SERVICE TECHNICAL INFORMATION

ONE POINT REPAIR

UTSUNOMIYA, APRIL 20, 1998
 REF. NO.: SI-98-004
 CUSTOMER RELATIONS & SERVICE DIV.

MODEL : NSX-V210
 SUBJECT : No power is turned on.
 DESCRIPTION : It may happen that CON101 of the front C. B and CON601 of the main C. B are disconnected due to a shock during transport and a failure such as "No power is turned on" is caused.
 For a device requested repair, take the following countermeasures regardless of existence of user's indication. This is applicable to devices produced since March 1997.

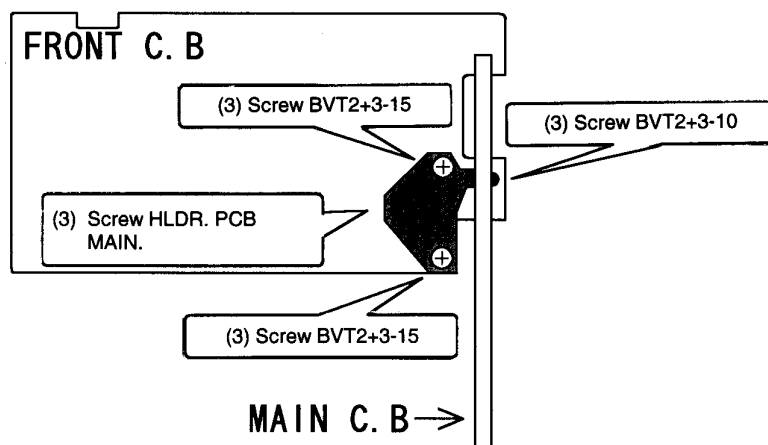
Countermeasure : (1) Loosen the two screws BVT2+3-10 on the front C. B.
 (2) Loosen the one screw BVT2+3-10 on the main C. B.

(3) Attach the HLDR, PCB MAIN with screws.

Note: Change the screws BVT2+3-10 attached to the front C. B to screws BVT2+3-15 and remain the screw BVT2+3-10 attached to the main C. B as it is.

Ref.	Part Name	Part No.	Remarks
***	HLDR,PCB MAIN	86-NFZ-223-010	
***	BVT2+3-15 W/O SLOT	87-067-581-010	2 screws used
